To: T10 Technical Committee
From: Tim Symons, PMC-Sierra (Tim_Symons@pmc-sierra.com)
Date: 5 September 2008
Subject: 08-360r3 SAS-2 ZONE GROUP VALID bit

The purpose of the ZONE GROUP VALID bit needs to be clarified. sas2r14d does not define when this bit is set to one or set to zero.

Figure 56 – Zoning expander route table

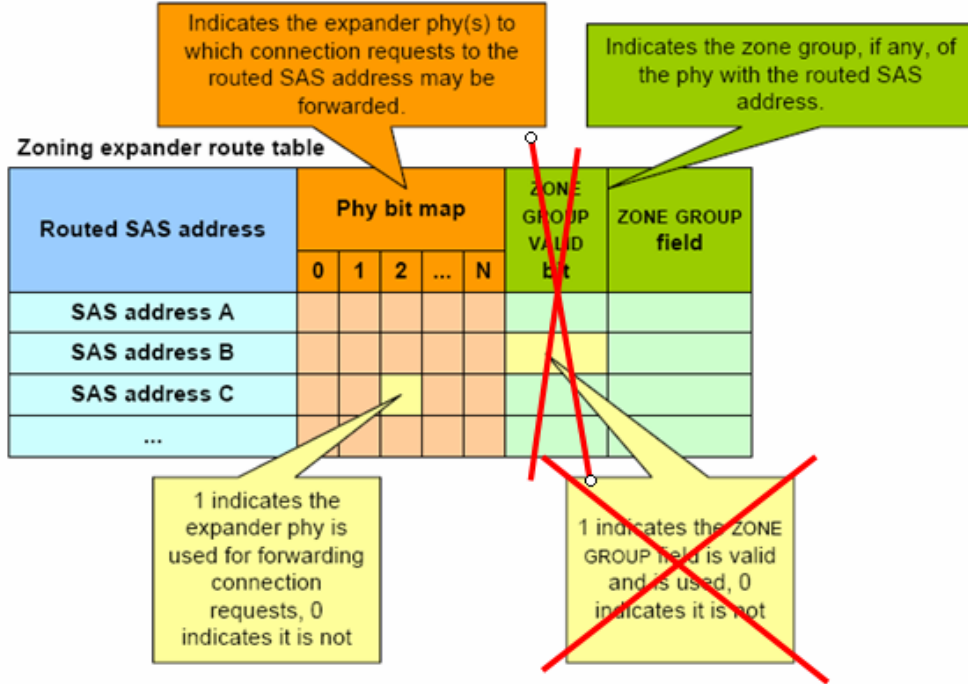
Other references for the ZONE GROUP VALID bit are in Figure 56 and Table 34 but both references are confusing and unnecessary.

Editors note : If zoning is enabled then the ZONE GROUP field is valid else it is not.
